GS# 102-292, STORM DAMAGE REPAIRS (PACKAGE A)
DELTA STATE UNIVERSITY
August 24, 2026

Addendum No. 2

BOLOGNAL PERFORMING ARTS CENTER (BPAC)

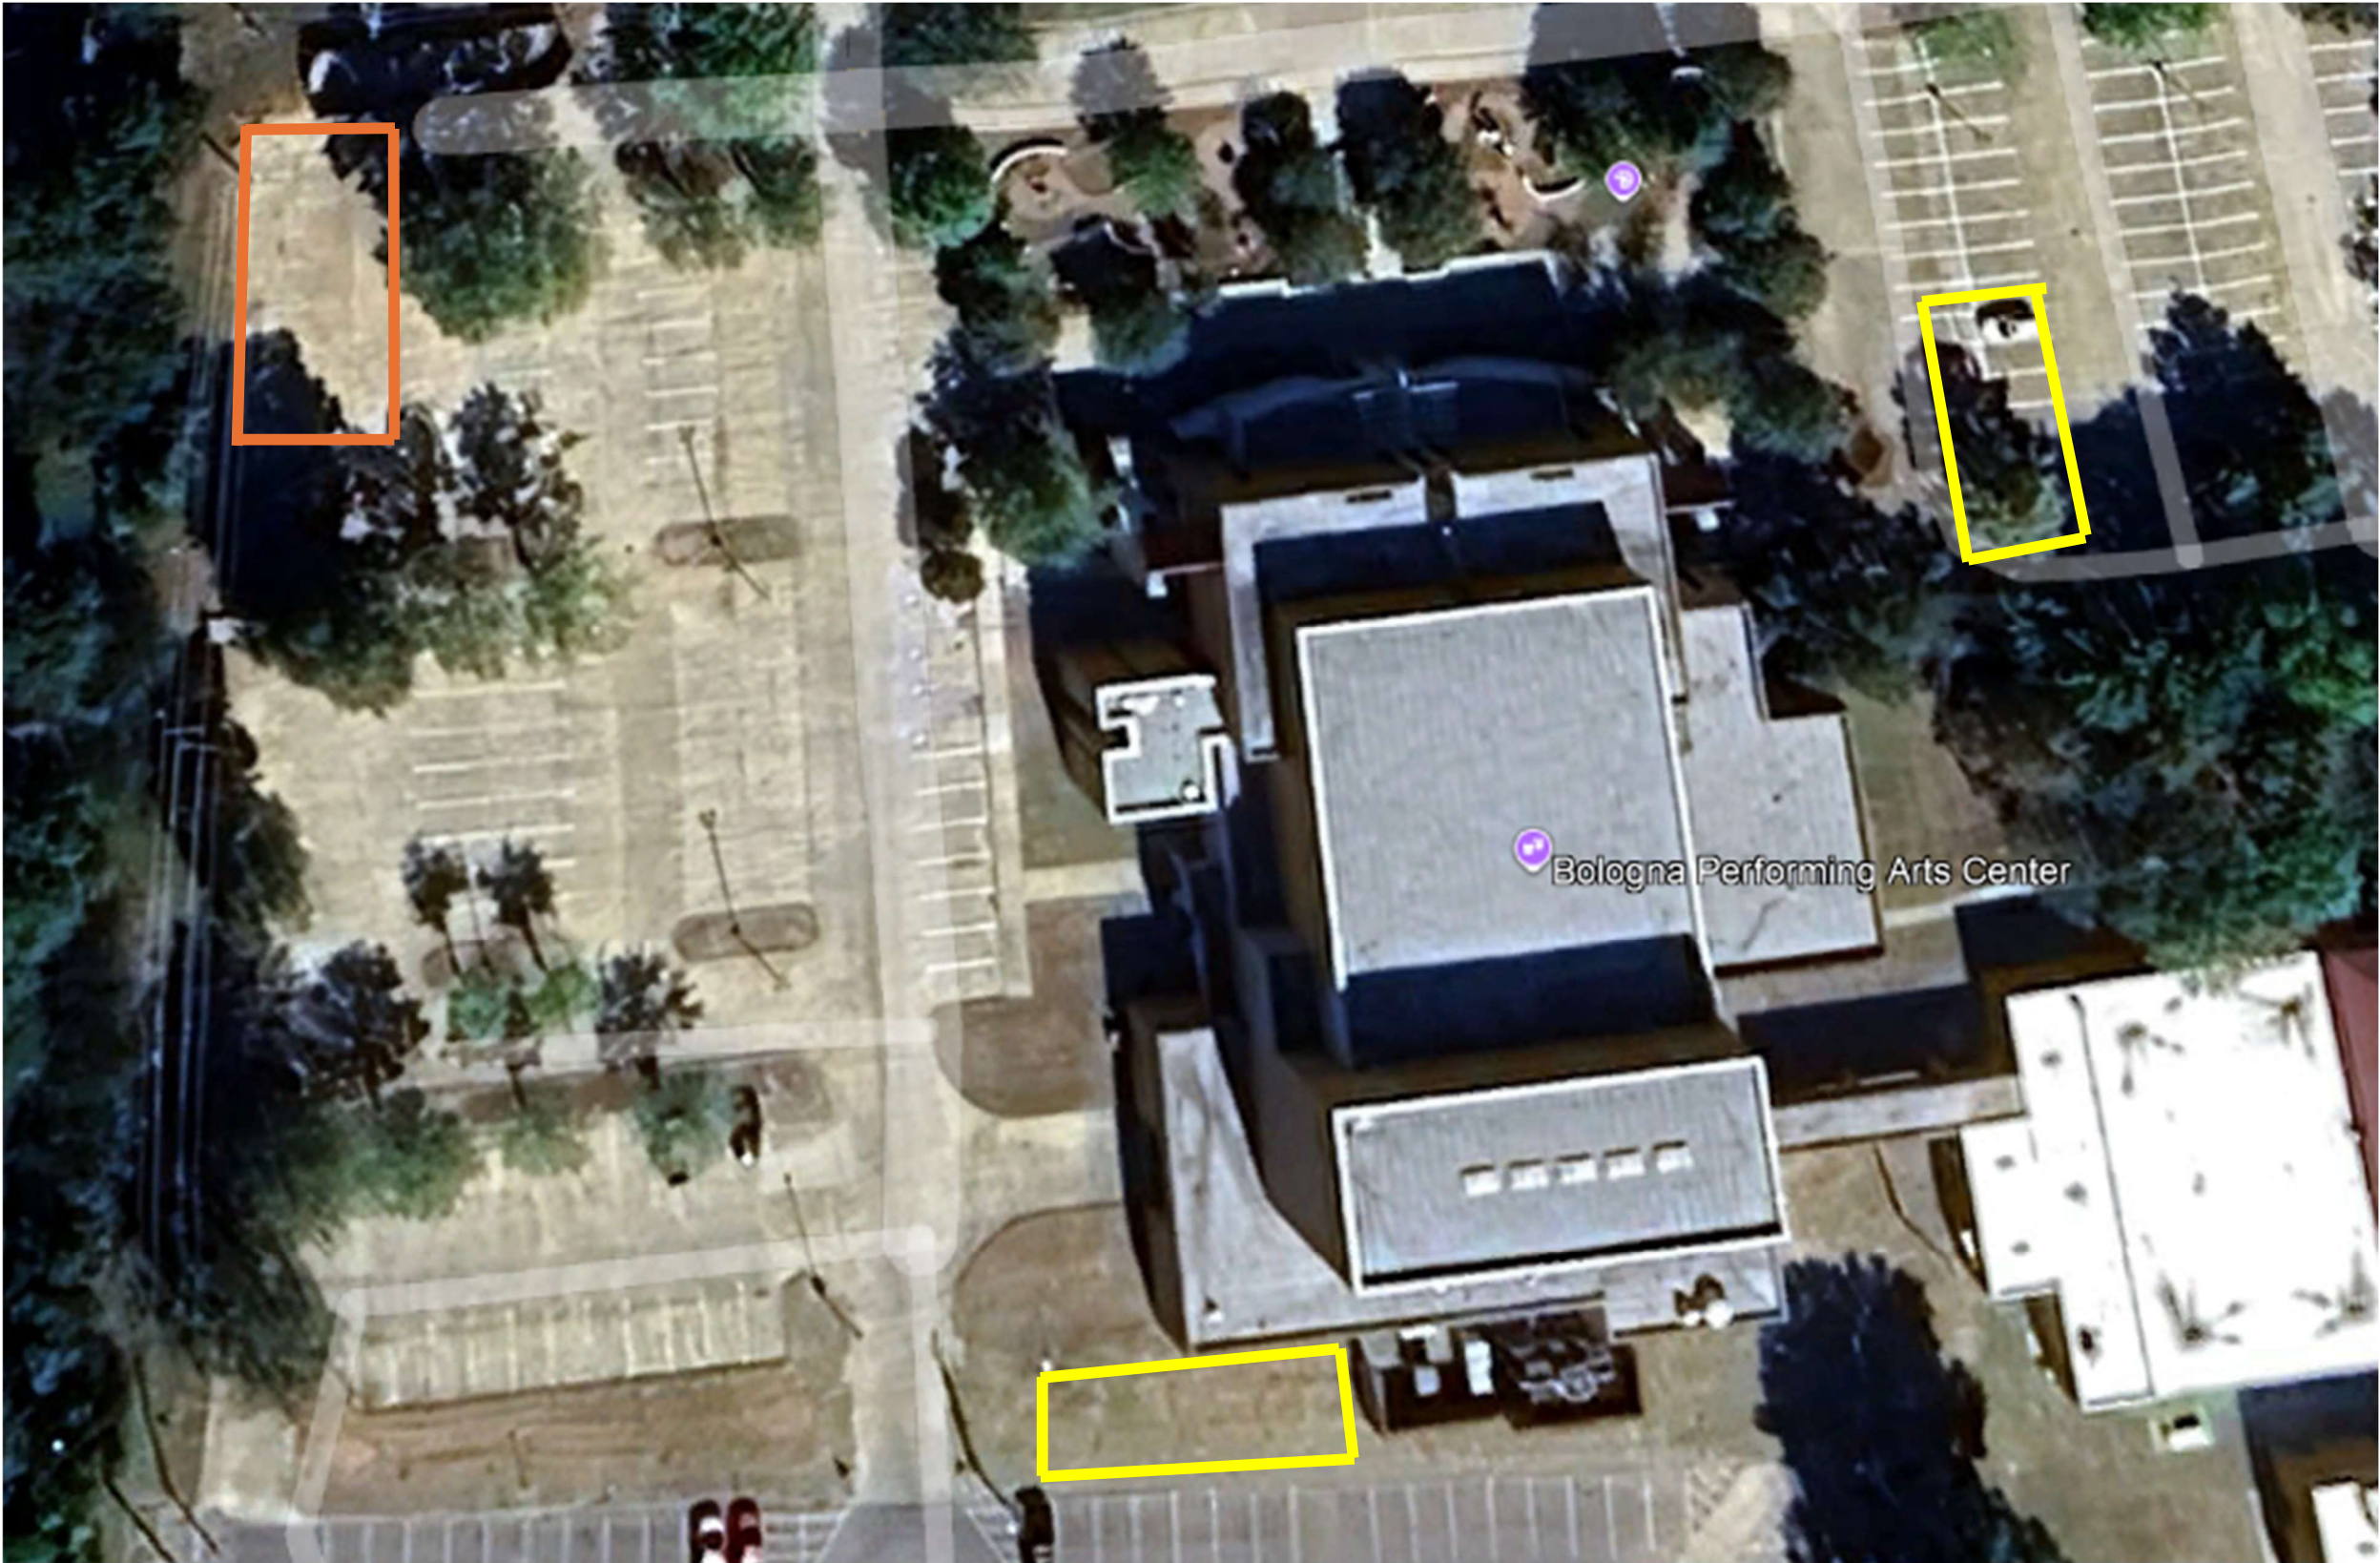
THE CONTRACTOR WILL BE ALLOWED TO PLACE A DUMPSTER, PARK, LAYDOWN MATERIALS, ETC. IN THE AREA INDICATED **IN ORANGE** IN THE DIAGRAM(S) BELOW. THIS LAYDOWN AREA IS TO BE ENCLOSED WITH CONSTRUCTION FENCING TO KEEP PEDESTRIANS FROM ENTERING THE SITE AND TO PROTECT THE PUBLIC IN GENERAL. ALL ACCESS AND EGRESS FROM THE BUILDINGS MUST BE MAINTAINED AT ALL TIMES UNLESS SPECIFIC PERMISSION IS GRANTED. ALL ROADWAYS AND DRIVING LANES MUST REMAIN OPEN UNLESS THE CONTRACTOR HAS OBTAINED PRIOR PERMISSION. THE CONTRACTOR IS TO IDENTIFY, PROTECT AND REPAIR ANY DAMAGE TO SIDEWALKS, SOD, TREES, UTILITIES, IRRIGATION, LIGHTS, DRIVES/CURBS, ETC. THE **YELLOW AREA** INDICTES GENERAL AREAS THAT THE UNIVERSITY MAY ALLOW FOR ROOF ACCESS DURING SPECIFIC TIMES THAT WORK IS BEING PERFORMED ON THE SPECIFIC ADJACENT ROOF AREAS. THE AREAS SHOWN ARE TO BE ENCLOSED BY CONSTRUCTION FENCING THAT IS 6-FOOT-TALL CHAIN LINK WITH FULL HEIGHT BLACK WIND SCREENS, WEIGHTED FEET WITH SANDBAGS.

JOBE HALL

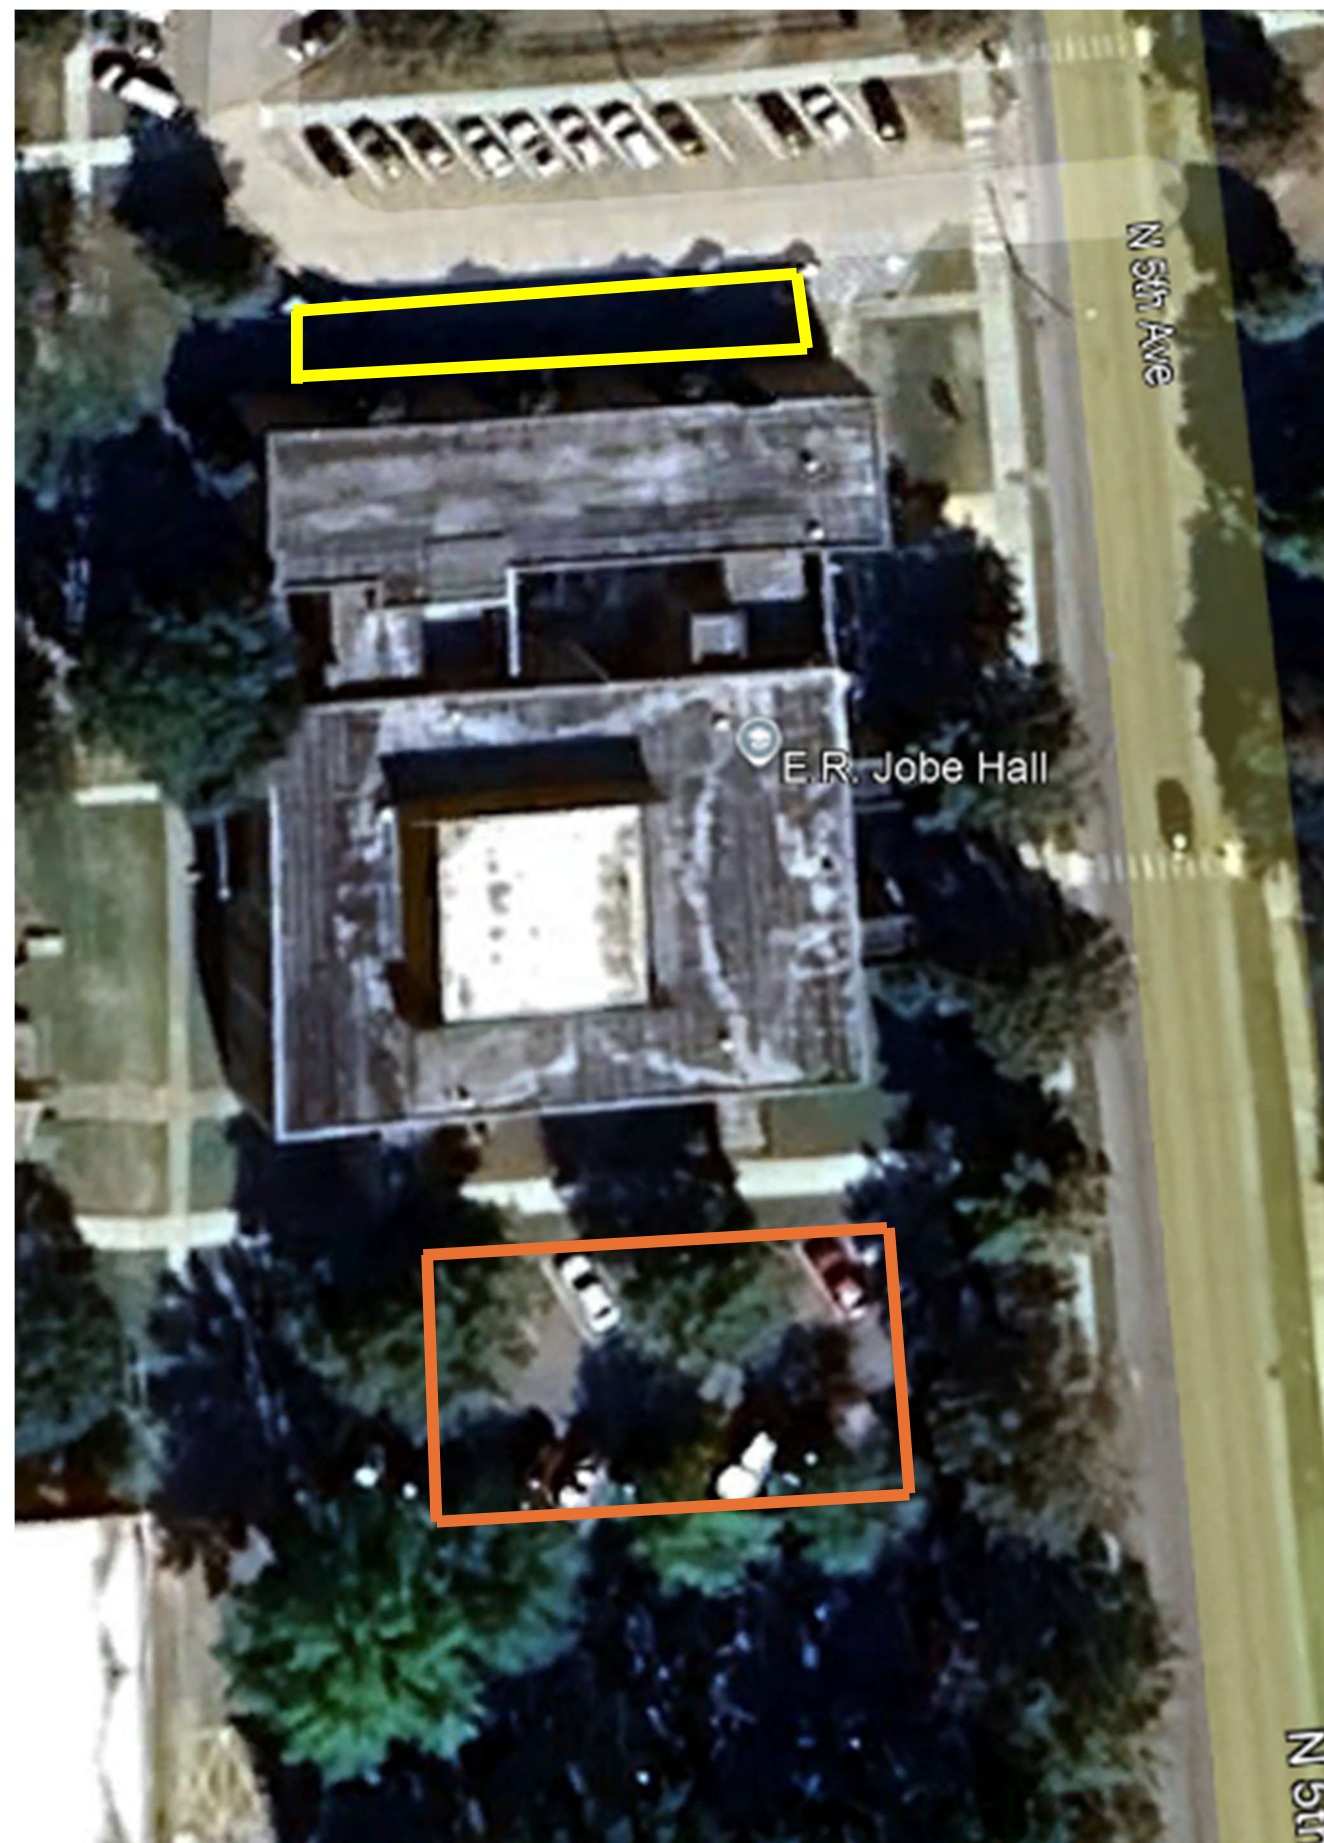
NOTE: NORTH AND SOUTH AREAS THAT ARE ADJACENT TO THE BUILDING ARE NOT TO BE USED CONCURRENTLY. THE LAY-DOWN LOT (EAST OF 4TH AVENUE) CAN BE USED AT ALL TIMES

ADD-2
DRAWING 2

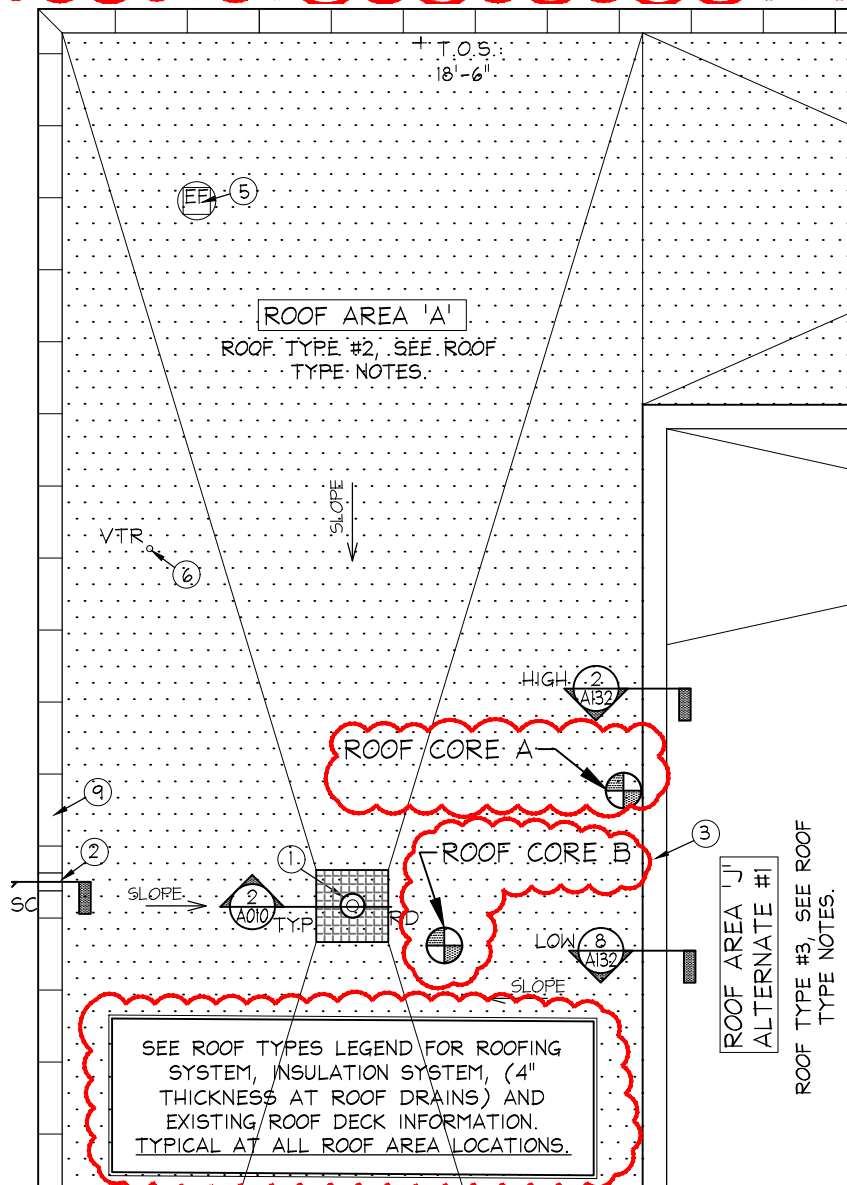
THE FOLLOWING TWO CORE SAMPLES WERE TAKEN ON THE SOUTH ROOF OF THE BOLOGNA PERFORMING ARTS CENTER (BPAC) ROOF. THIS IS SHOWN AS ROOF AREA 'A'.

BPAC-A: 5 1/2" THICK AT WALL
BPAC-B: 4" THICK AT DRAIN

ROOF TYPES - (BPAC): (ADDENDUM #2)

ALL ROOF DECKS ARE TO BE CLEANED AND PRIMED PRIOR TO INSTALLATION OF NEW ROOFING SYSTEM. INFILL ALL ROOF OPENINGS NO LONGER IN USE. VERIFY OWNER/ ARCHITECT PRIOR TO DECK PATCHING. INSTALL NEW ROOFING SYSTEM AS RECOMMENDED BY THE MANUFACTURER FOR THE GIVEN CONDITION.

- a) The starting thickness of tapered insulation on the Bologna Performing Arts Building (BPAC) shall now be 4" at the drains, with at 1/8" per foot taper.
- b) The north roof section of Jobe Hall shall have a starting thickness of 3 ½" at the drains, with a 1/8" per foot taper. The south roof section will remain the same as shown on the drawings.
- c) The starting thickness of all tapered insulation on Caylor-White-Walters shall be 2" at the drain, with a 1/8" per foot taper.
- d) The starting thickness of the tapered insulation on the lower (non-barrel vaulted) roof sections of the Whitfield Gymnasium/Delta Music Institute (DMI) shall be 4 ½" at the scuppers, with a ¼" per foot taper.

SHEET
ADD-2
DRAWING 4

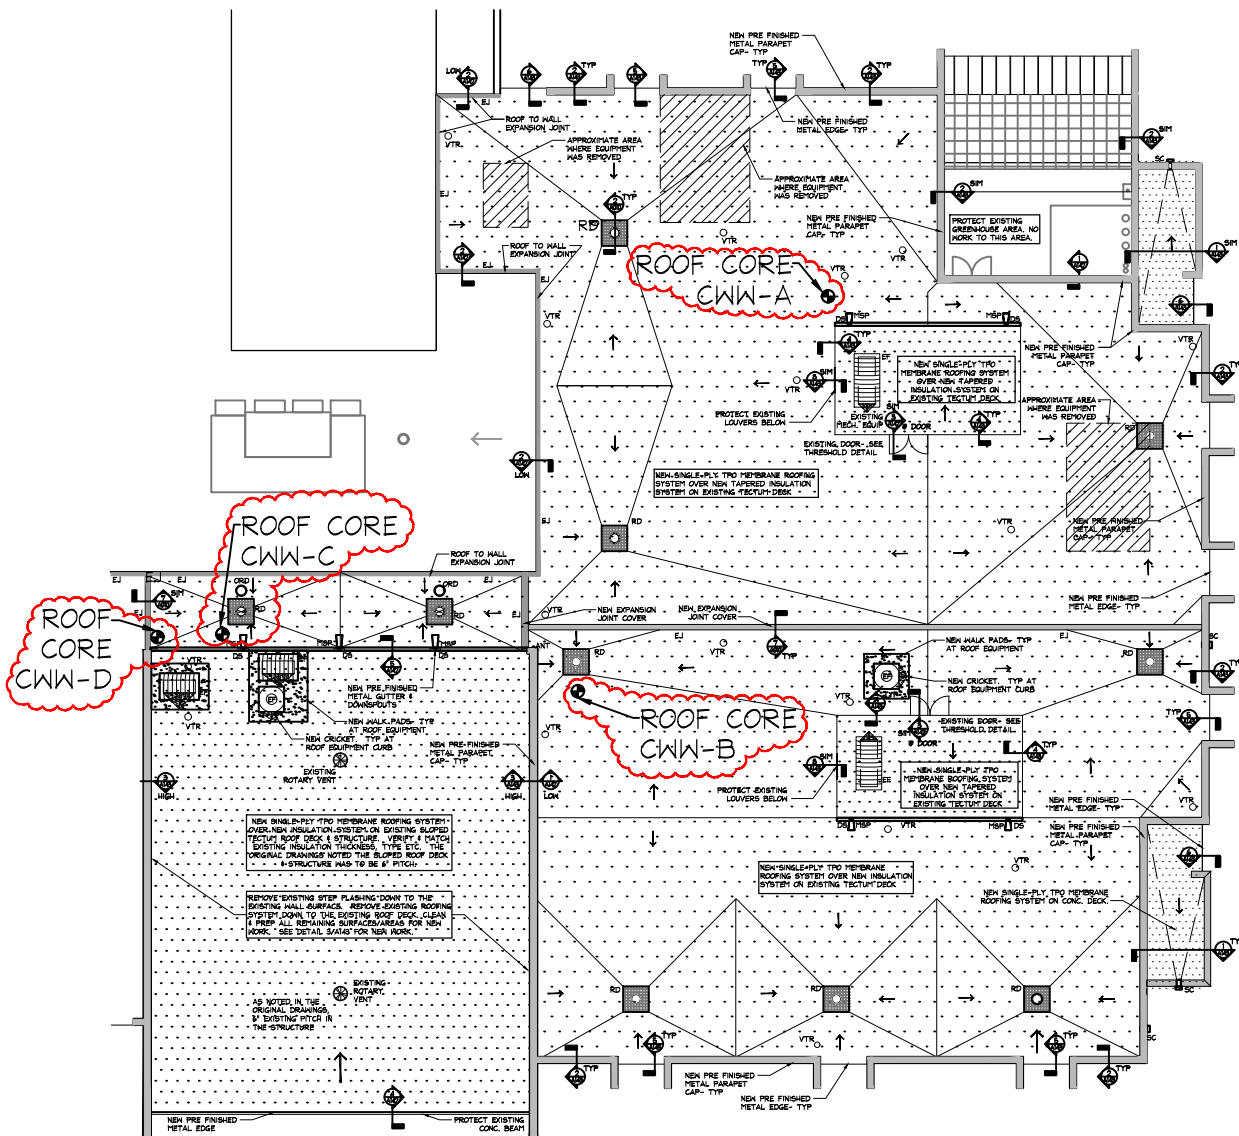
SEE DRAWING 5 FOR ROOF CORE INFORMATION
AT THE SOUTH END OF THE BUILDING

THESE CORES WERE TAKEN ON THE NORTH END OF THE BUILDING. SEE ROOF PLAN SHEET A140 FOR CORE LOCATIONS.

NOTE: THERE MAY BE SOME VARIATION IN THE DEPTHS OF THE ROOF CORES. AS A RESULT, ALL DEPTHS SHOULD BE READ AS +/- CONTRACTORS SHOULD VERIFY ANY CONDITIONS IN QUESTION.

THE FOLLOWING CORES WERE TAKEN ON CAYLOR-WHITE-WALTERS ON THE SOUTH AND MORE CENTRAL ROOF AREAS. SEE DRAWING 4/ADD-2 FOR LOCATIONS.

CWW-B: SOUTH-WEST ROOF SECTION - 2" THICK AT DRAIN. MOD BIT, POLY-ISO, TECTUM (SMOOTH TOP TECTUM THAT ALMOST LOOKED LIKE A CONCRETE PLANK (MAY HAVE BEEN A SLURRY COAT OR AT JOINTS OF TECTUM)).

6. See the additional core information that was taken on site during the roof visits immediately after the pre-bid meeting (attached drawings ADD-2, DRAWINGS 1-5). This newly supplied information is to be used with the details, drawings and notes in the bid documents. Note that the insulation thicknesses that are provided with these roof cores will define the starting thicknesses and taper slopes. This new information shall replace and/or supplement any previously supplied information that it contradicts.
